**Attachment 11 – Conditions of Site Plan Approval (City of Vaughan)**  
**Site Development File DA.19.016 (2678463 Ontario Ltd. (Cortel Group))**

**Re: 1<sup>st</sup> Submission Site Plan Comments**  
**Phase 1 – 1890 Highway 7**  
**City of Vaughan**  
**Town File No.: DA.19.016**  
**Our File No.: SP.24.V.0059**

**BLOCK 2**  
**SILTATION CONTROL PLAN**

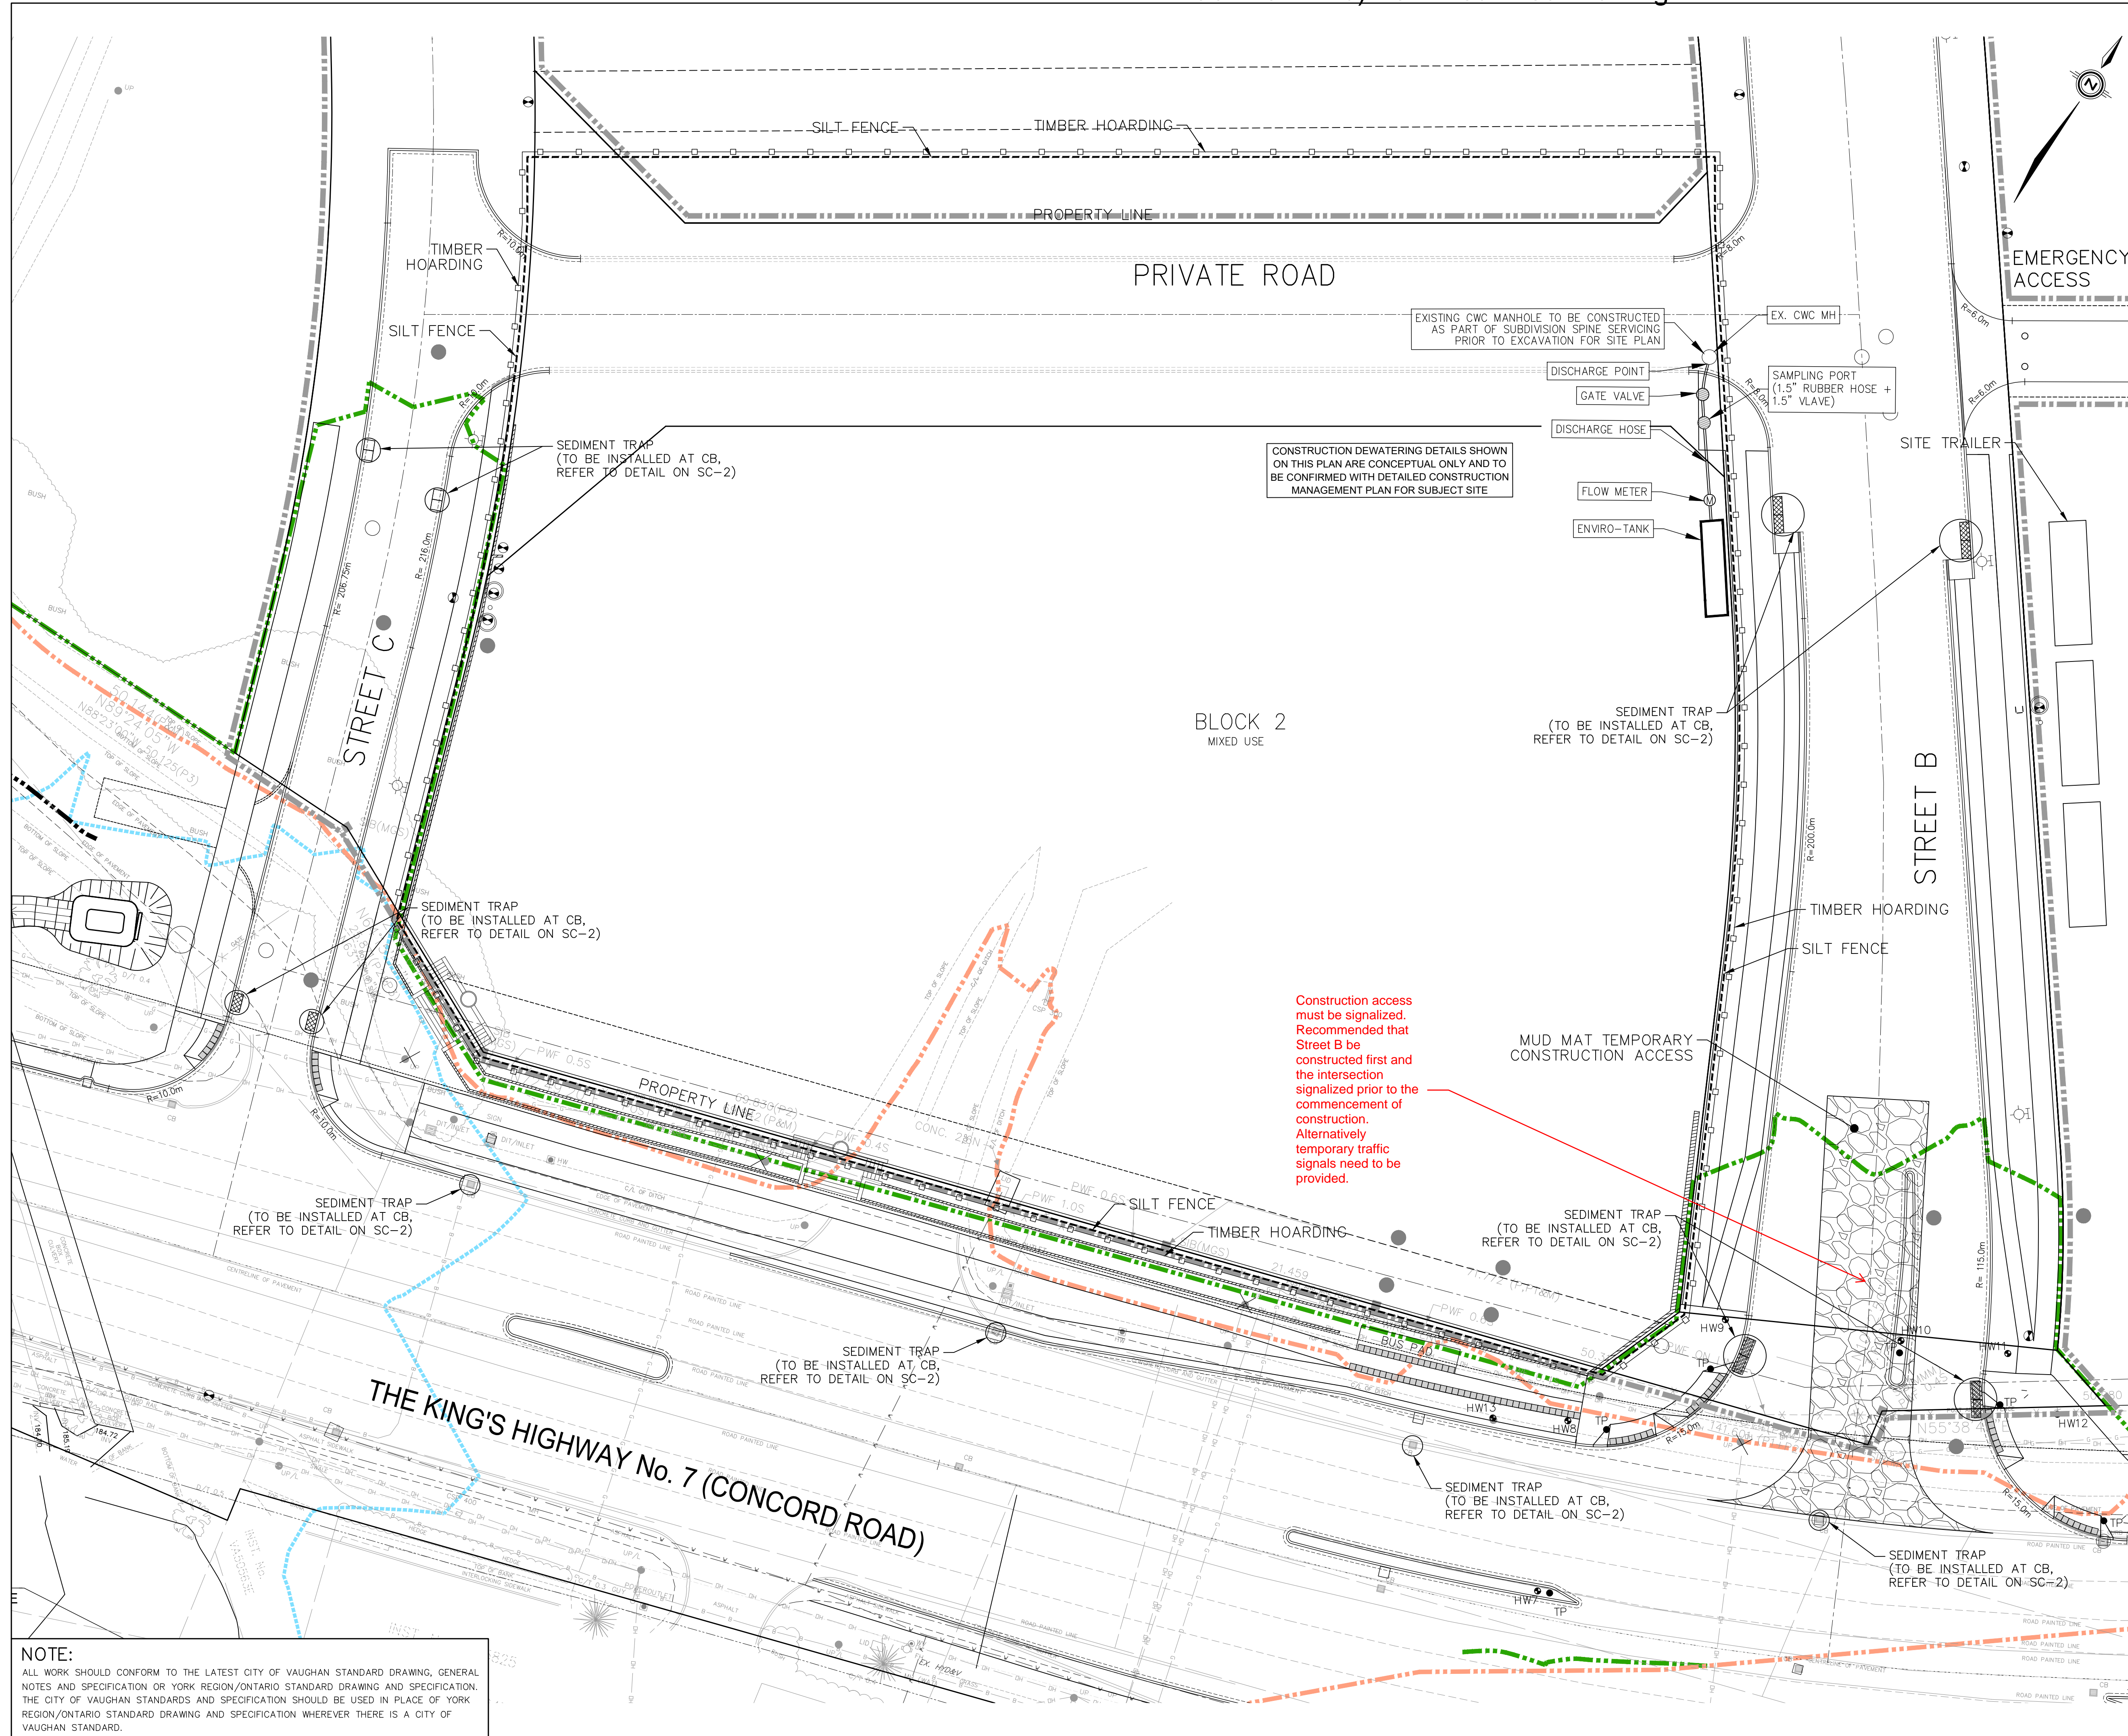
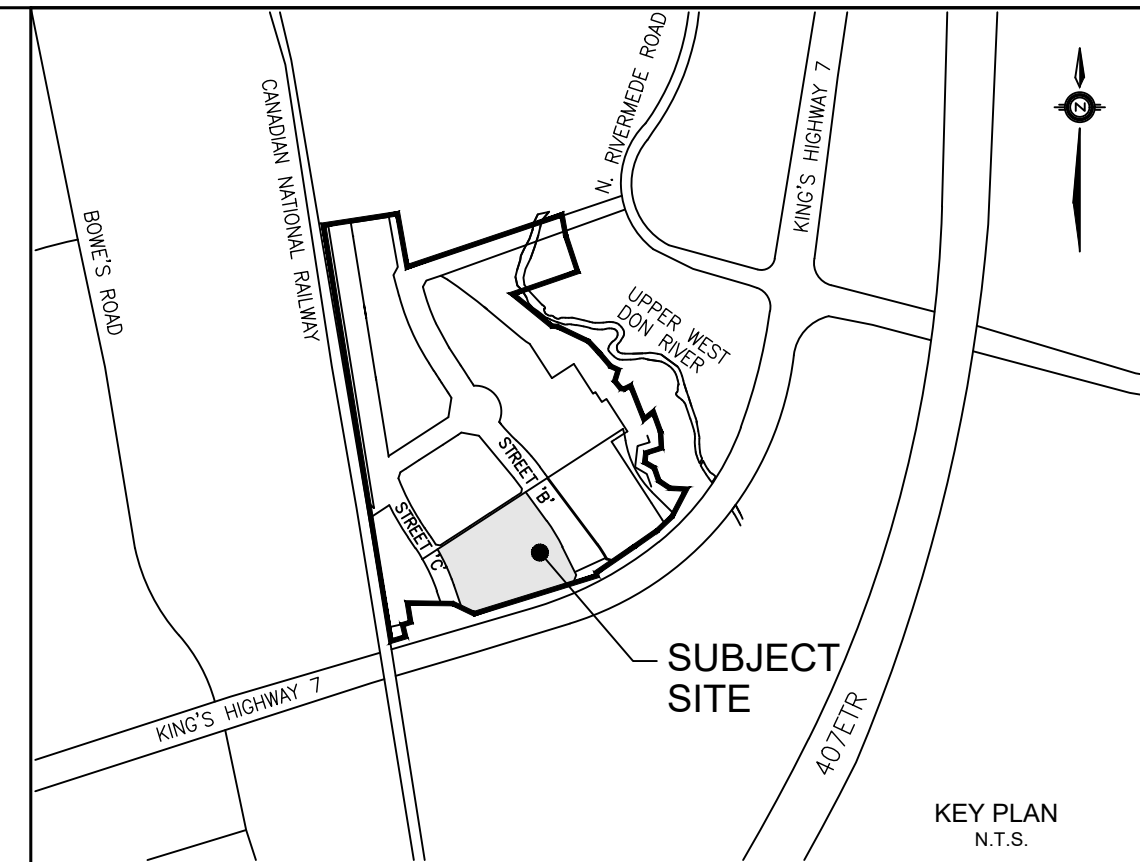
Construction access must be signaled. Recommended that Street B be constructed first and the intersection signaled prior to the commencement of construction. Alternatively temporary traffic signals need to be provided.
